Intel[®] 80303 and 80302 I/O Processors

Specification Update

May 6, 2003

Order Number: [273355-010](#)

2. Figure 9-3 on pg 9-9 did not print correctly

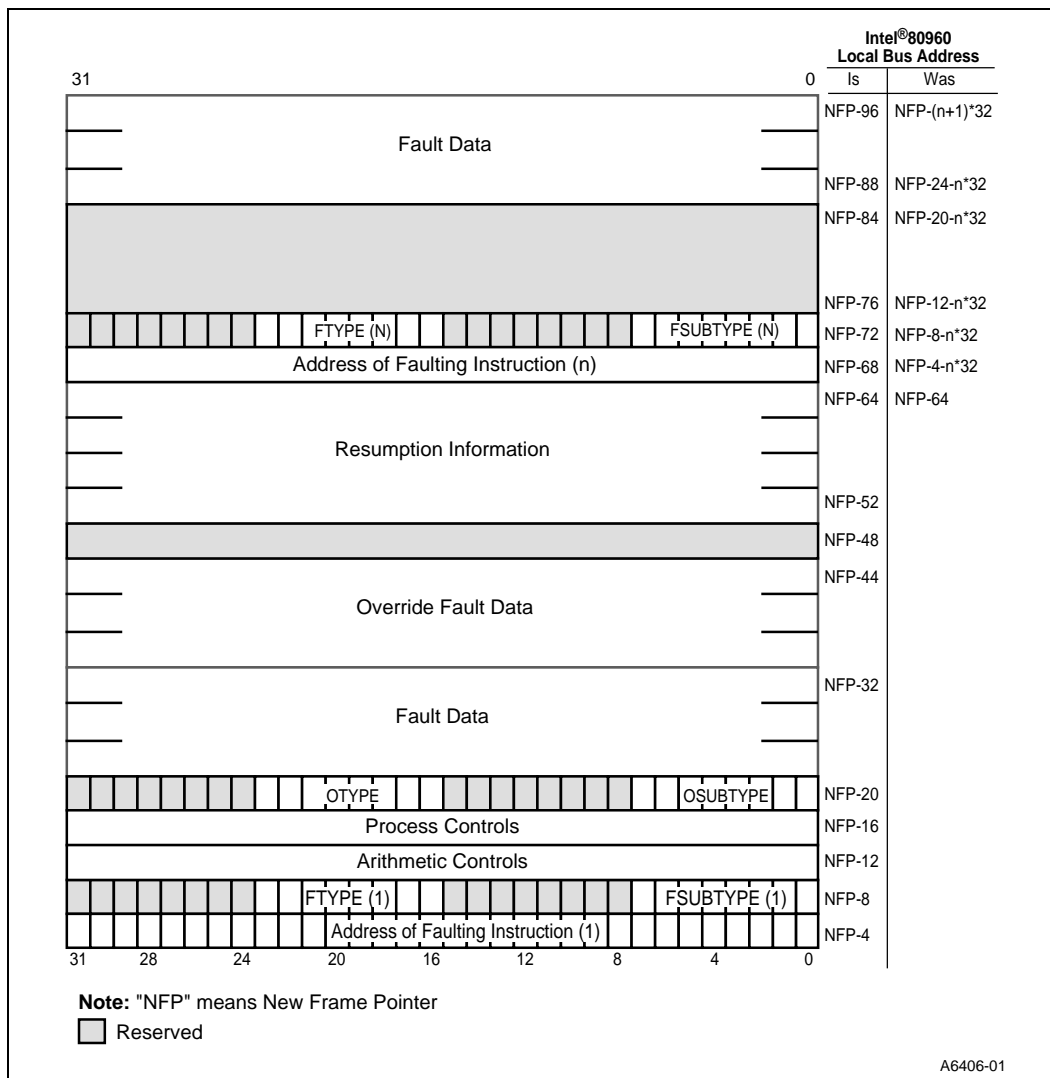
Problem: Figure 9-3 on pg 9-9 did not print correctly.

Workaround: Replace Figure 9-3 with the following:

3. Figure 13-22 on pg 13-40 did not print correctly

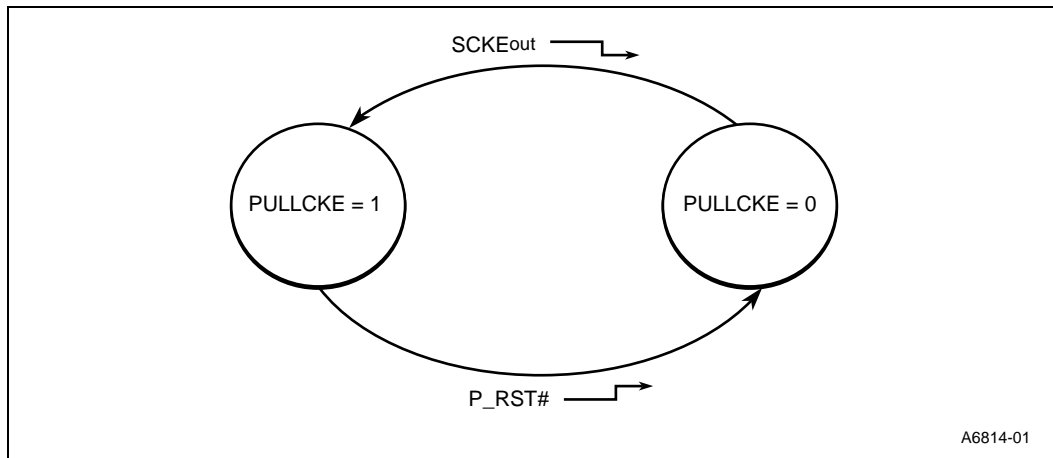
Problem: Figure 13-22 on pg 13-40 did not print correctly.

Workaround: Replace Figure 13-22 with the following:

4. Figure 13-18, pg 13-35

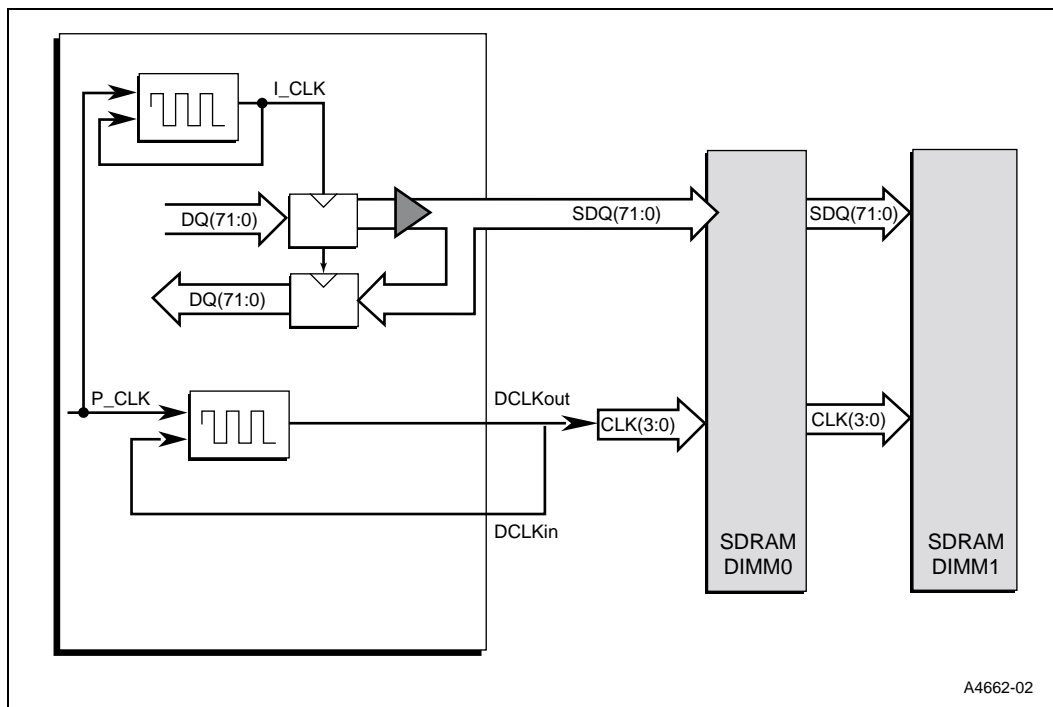
Problem: Replace Figure 13-18 with the following:

5. **Figure 15-2 on pg 15-3 did not print correctly**

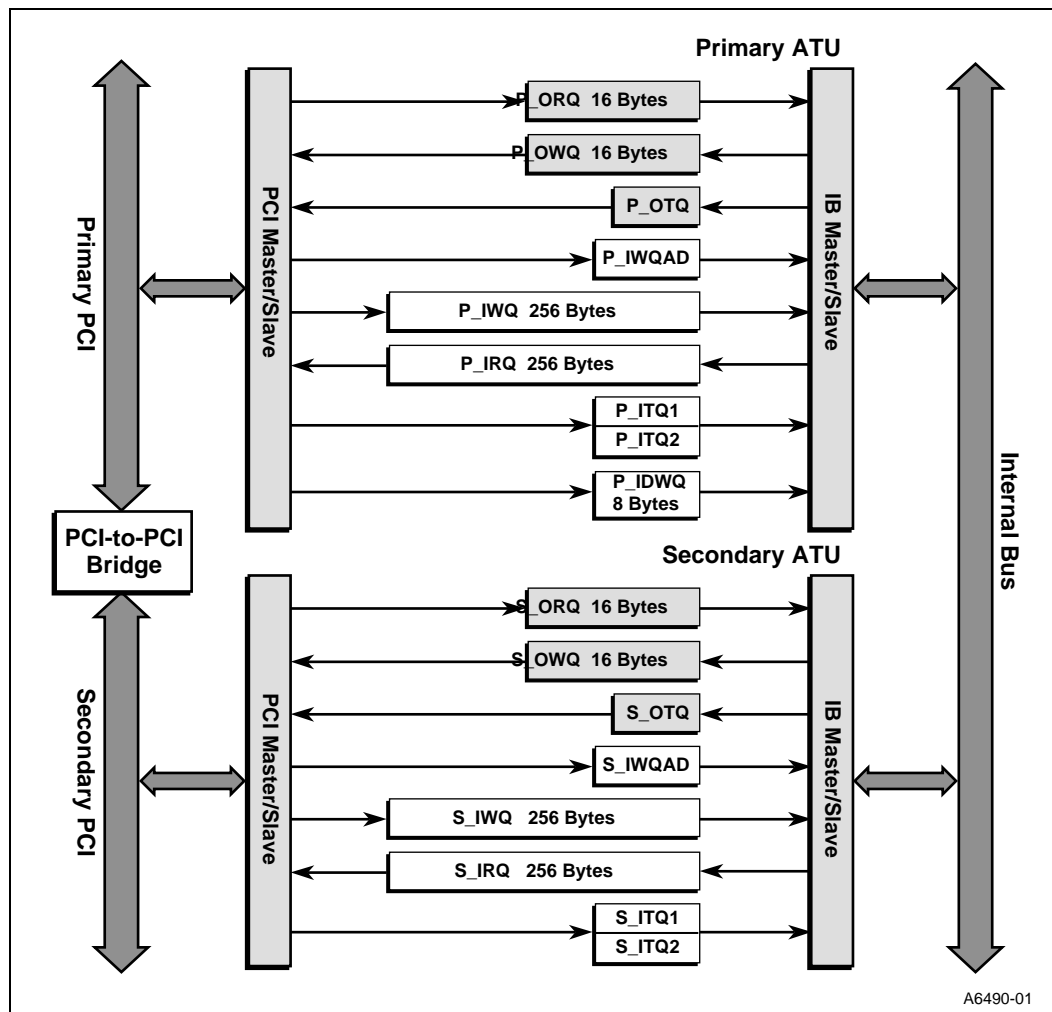
Problem: Figure 15-2 on pg 15-3 did not print correctly.

Workaround: Replace Figure 15-2 with the following:

Figure 25-1. Intel® 80303 I/O Processor Clocking Regions Diagram

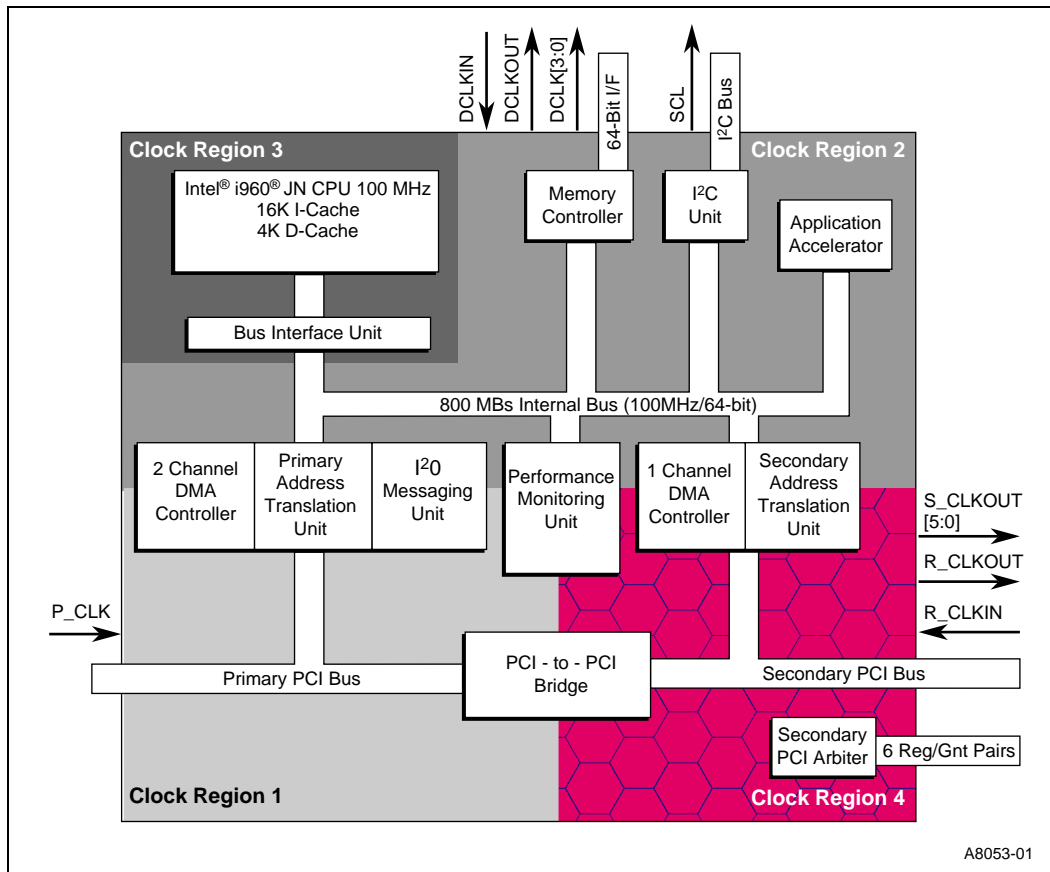
Problem: The Internal bus in diagram shows 66 MHz bus speed. The actual bus speed is 100 MHz

Workaround: Replace Figure 25-1 with the following:

11. Figure 25-2 on pg 25-2 did not print correctly

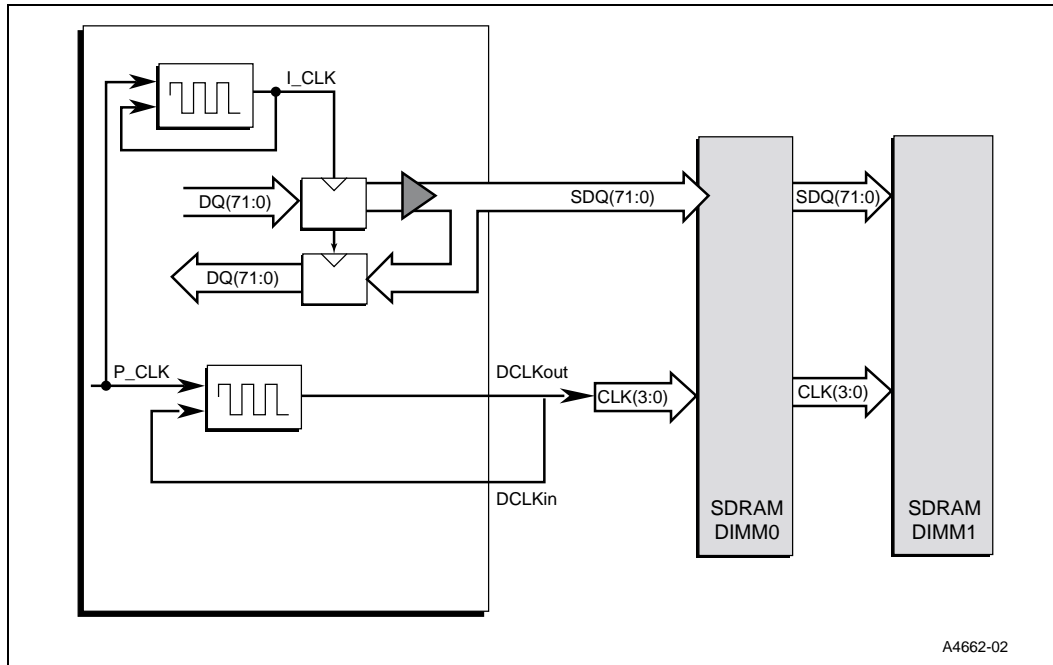
Problem: Figure 25-2 on pg 25-2 did not print correctly.

Workaround: Replace Figure 25-2 with the following:

Figure 12-2. Core Processor/BIU Interface Block Diagram

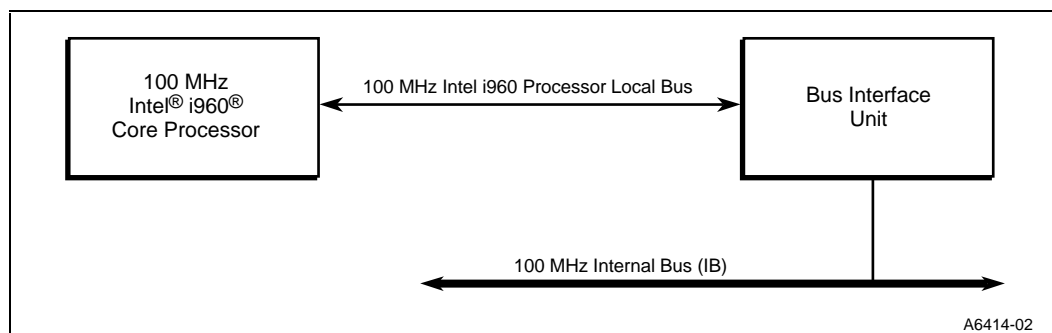
Problem: The Internal bus in diagram shows 66 MHz bus speed. The actual bus speed is 100 MHz

Workaround: Replace Figure 12-2 with the following:

18. Figure 15-3 on page 15-7 has missing text

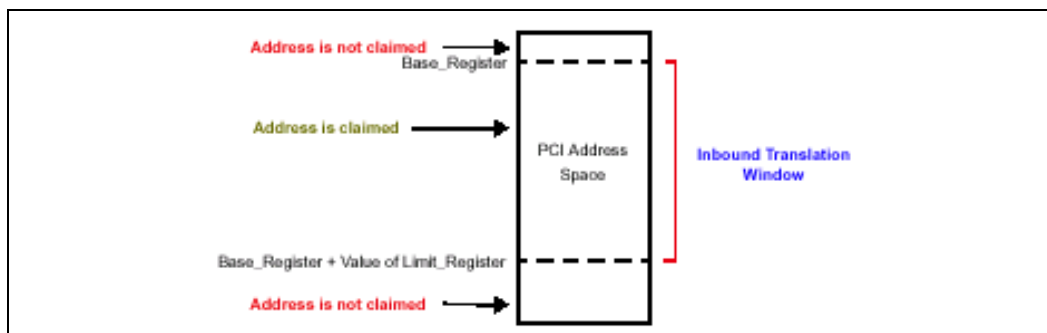
Problem: The figure shows 'se_Register + Value of Limit_Register'. It should be 'Base_Register + Value of Limit_Register'.

Workaround: Replace Figure 15-3 with the following:

Figure 13-16. ECC Read Data Flow

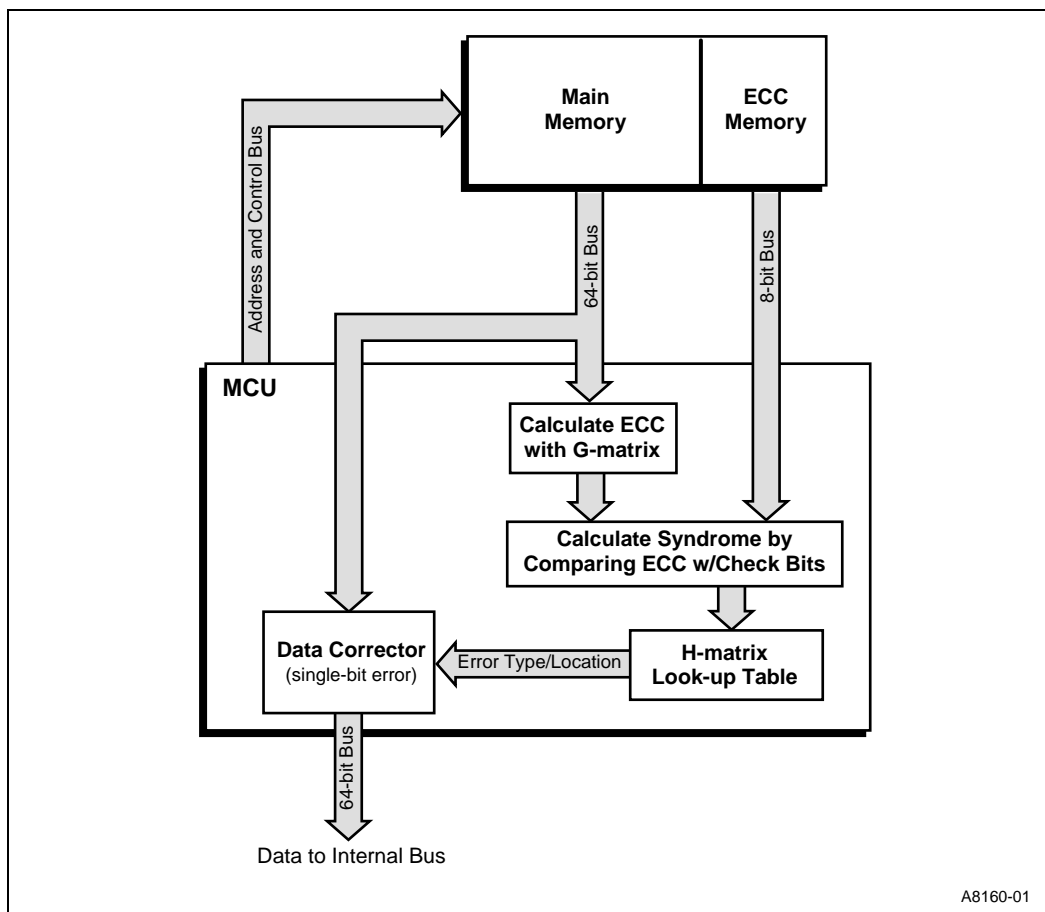
Figure 13-16 shows how the data flows through the ECC hardware for a read transaction.

Workaround: Replace Table 13-13 with the following and, add the adjacent paragraph with “new” Figure 13-16:
